Re: Response to Review of Response to Comments
The Sanctuary at Manchester-by-the-Sea – School Street
Manchester-by-the-Sea, Massachusetts

Vanasse & Associates, Inc. (VAI) is providing responses to the comments that were raised in the March 4, 2022 *Review of Response to Comments #2* letter prepared by Environmental Partners (EP) in reference to their review of the February 28, 2022 *Response to Transportation Peer Review* (the “February 2022 RTC”) prepared by VAI in support of The Sanctuary multifamily residential development to be located off School Street in Manchester-by-the-Sea, Massachusetts (hereafter referred to as the “Project”). Listed below are the comments that were identified by EP in the subject letter that required a response or supplemental information, followed by our response on behalf of the Applicant.

Conceptual Improvement Plan
School Street at Mill Street and
Route 128 Northbound Ramps
Sheet 1 of 2

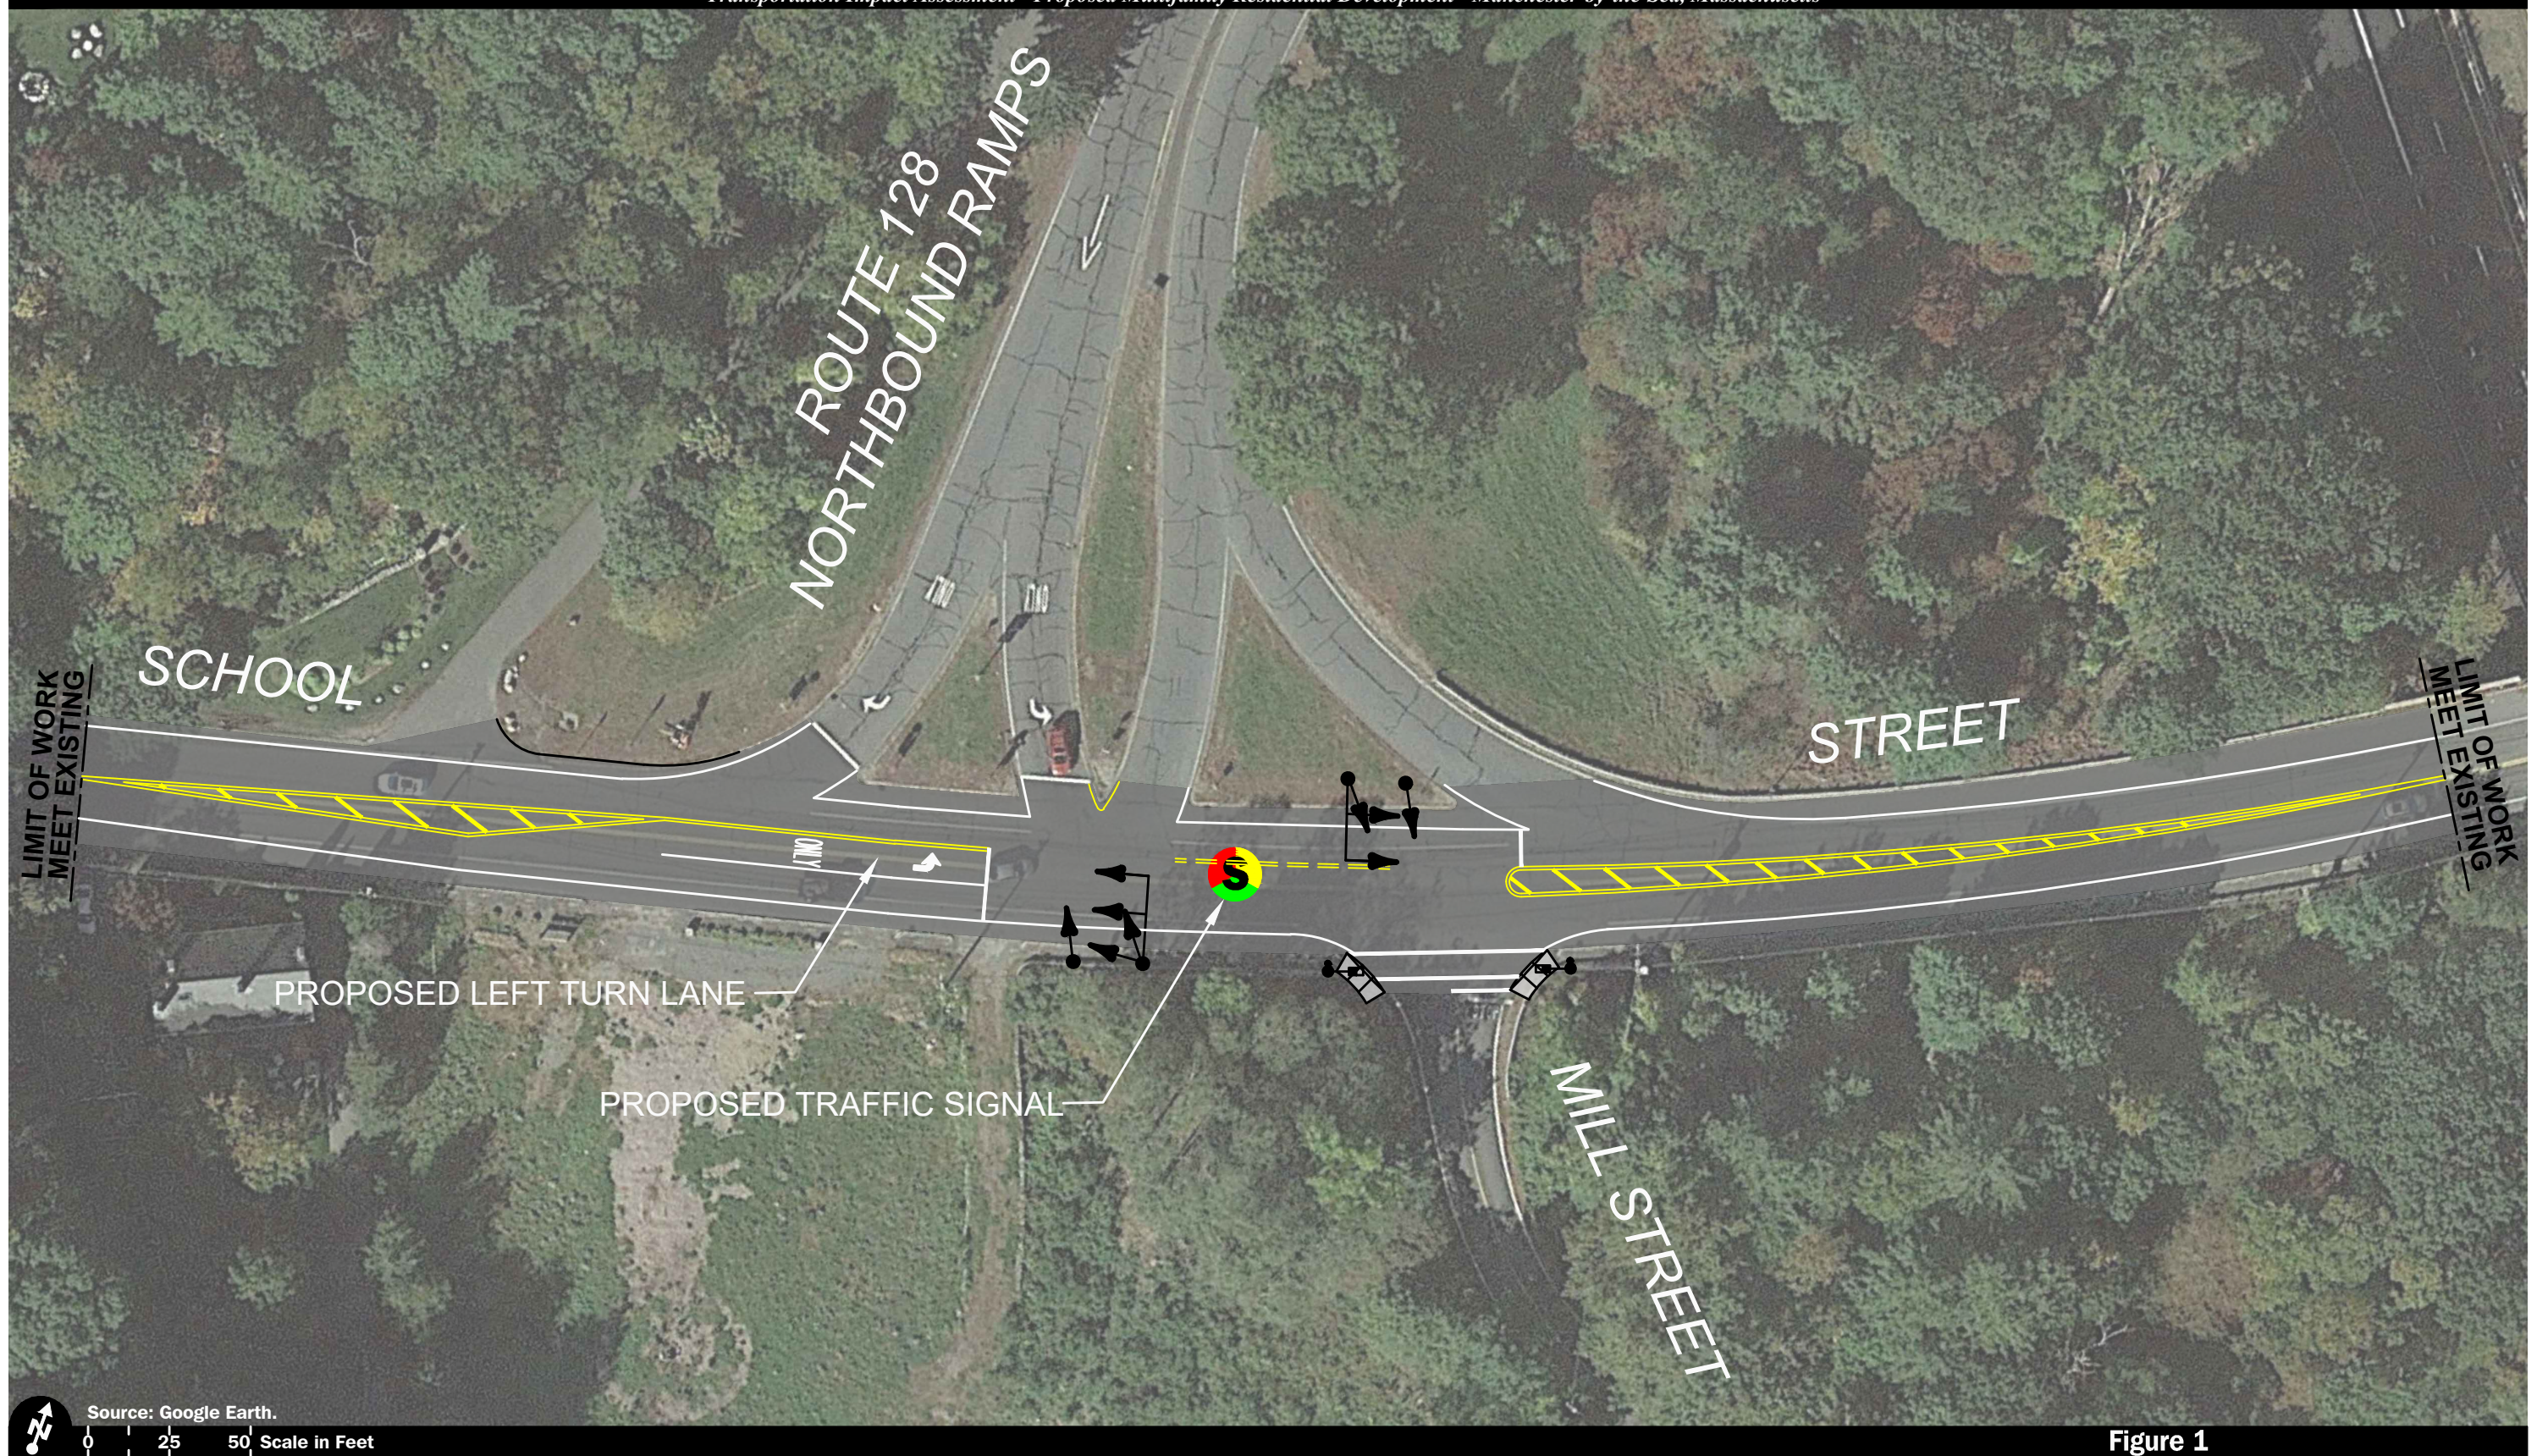
EP Follow-Up: *EP encourages the Applicant and the Town to continue coordination to establish a “fair-share” contribution. We note that the \$590,000 cost cited is likely to be inadequate for both design and construction of two separate signalized intersections meeting MassDOT design standards.*

Response: In furtherance of refining the “fair-share” contribution toward the improvements for the Route 128 north and southbound ramp intersections with School Street, a conceptual improvement plan has been prepared and is attached that illustrates the improvements that form the basis of the cost estimate. The estimated cost to design and construct the improvements that are depicted on the concept plan is estimated to be \$890,000, higher than the previous estimate due to the expended work that is shown to include the addition of left-turn lanes and pedestrian accommodations. Based on the new estimate, the fair-share cost allocation to the Project to design and construct the improvements is \$44,500 ($5\% \times \$890,000 = \$44,500$).
